Re: Item B1. DRP for 241 Pacific Avenue

There are important inconsistencies in the applicant's geotechnical report that should be corrected. As a result of these inconsistencies and errors, per Solana Beach's Certified Land Use Plan (LUP), council is not permitted to approve the proposed development. We are asking Council to deny the permit as the proposed development will all be seaward of the GSL inconsistent with LUP policy 4.17.

2019 Application No. 6-18-0288, Exhibit No. 4²

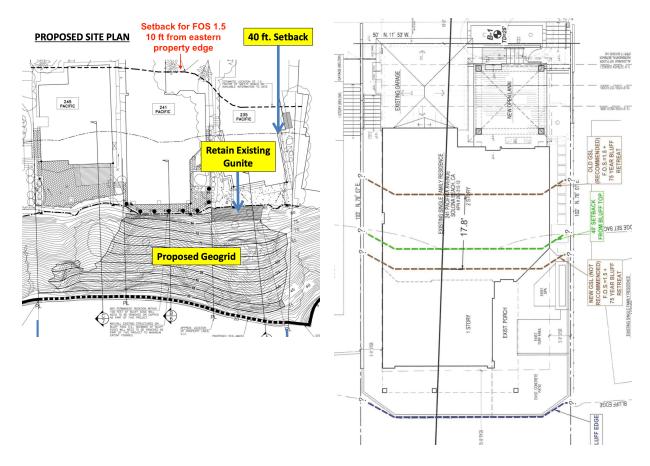
In the 2019 California Coastal Commission staff report for the approval of the seawall in front of 241 Pacific Ave, the following was in evidence showing the 1.5 Factor of Safety (FOS) was 10 feet from the <u>eastern</u> property line when calculating the setback, even absent consideration of the additional 75 years of erosion.

"Relocation is another alternative that is typically considered a reasonable and feasible alternative to consider. The Commission typically requires that new homes be sited landward of the Geologic Setback Line (GSL) on bluff top sites, which consists of the combination of the current 1.5 Factor of Safety (FOS) setback and 75 years of expected erosion. On the subject sites, it would not be feasible to construct homes landward of the GSL, as the identified 1.5 FOS Setback alone is located ~10 ft. from the eastern property line at 241 Pacific Avenue and ~25-35 ft. from the eastern property line at 235 Pacific Avenue." (emphasis added, page 31, Th20b-d-2019 report)¹

The 10 ft from the eastern property line data point is consistent with the 2019 Coastal Commission permit application, Exhibit No. 4, and is not consistent with the present application showing the setback seaward of the garage. In the 2019 Exhibit No. 4, the GSL traversed the middle of the garage.

Exhibit 4 from the 241 Pacific Staff 2019 Report shows the setback line (dashed line at top) for a Factor of Safety 1.5 approximately 10 feet from the eastern edge of the property and traversing through the garage. A factor of safety line at this location would prohibit <u>any</u> development since the factor of safety 1.5 line is the most conservative position of the GSL. When retreat rate due to SLR and waves are added the GSL is likely to be in the middle of Pacific Ave.

2023 Re-revised Bluff Retreat Map, Plate 1a (B.1. Updated Report)

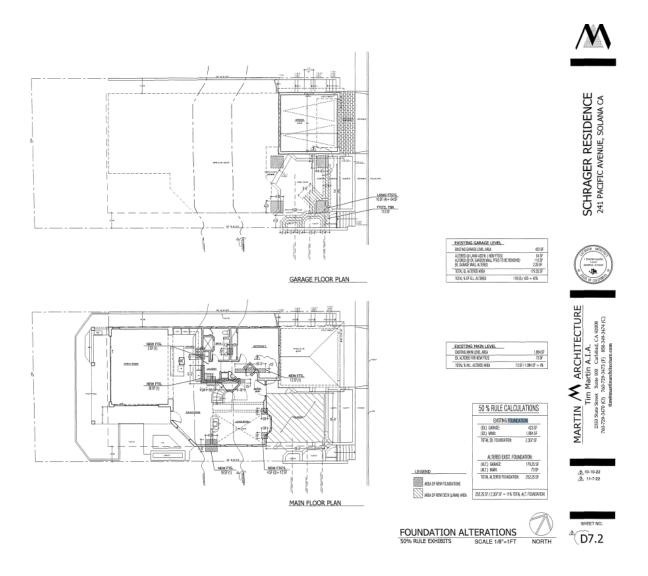
The applicant's latest inconsistent submission is not surprisingly labeled "re-revised". The "re-revised" calculation incorrectly shows the Factor of Safety 1.5 line considerably seaward of the line 10 feet from the eastern property edge used in the 2019 seawall application Staff Report.

Also inconsistent with the present appliction's assumptions is the factor of safety for the principal structure absent the seawall. As submitted by Terra Costa and concurred by the Coastal Commission engineer and geologist, a Slope static/pseudostatic stability Factor of safety of 1.12/0.90 was calculated at 241 Pacific Ave 20 feet inland of the bluff edge:

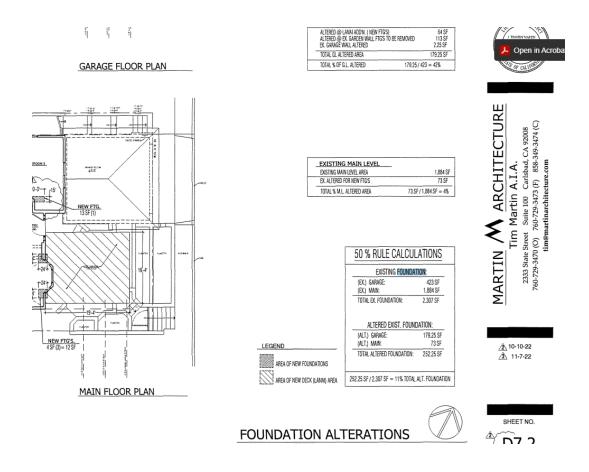
"At the subject site, an ~10 ft. thick clean sand layer is exposed across a 74 ft. long section of the bluff. The slope stability analysis performed by the applicants' engineer indicates that further collapse of the upper bluff would threaten the structures at the top of the bluff. Slope static/pseudostatic stability analyses for the bluff at 235 Pacific, 241 Pacific, and 245 Pacific demonstrate a factor of safety of 1.22/0.95, 1.12/0.90, and 0.99/0.80, respectively. These factors of safety alone may not necessitate shoreline protection. However, when taken in combination with the exposure of the clean sand layer, the Commission senior engineer and geologist agree that the applicants' geotechnical analysis conclusion that each of the three residences are at risk, and that shoreline protection is warranted." (page 28, Th20b-d-2019 report)¹.

"Slope stability analyses conducted for 241 Pacific Ave. provided by TerraCosta (2010) (Ref. 2) and SEC (2018a) (Ref. 8) report low minimum factors of safety (1.12 static / 0.90 seismic; Ref. 8) along critical surfaces daylighting approximately 20 feet inland of the bluff edge, which, as noted above, had by 2018 retreated to the margins of the existing drilled pier system (Ref. 10). Neither of these analyses included the existing piers and any stability benefits the system may still afford, 1 making it difficult to evaluate the actual stability of the bluff under existing conditions." (Th20b-d-2019 Exhibits, Exhibit No. 15 Geotechnical Review Memorandum, page 3)²

As shown below the <u>new foundation for the covered porch</u> (lanai) is clearly seaward of the Factor of Safety 1.5 line as the porch is virtually parallel to the garage. This development cannot be allowed per LUP Policy 4.17:
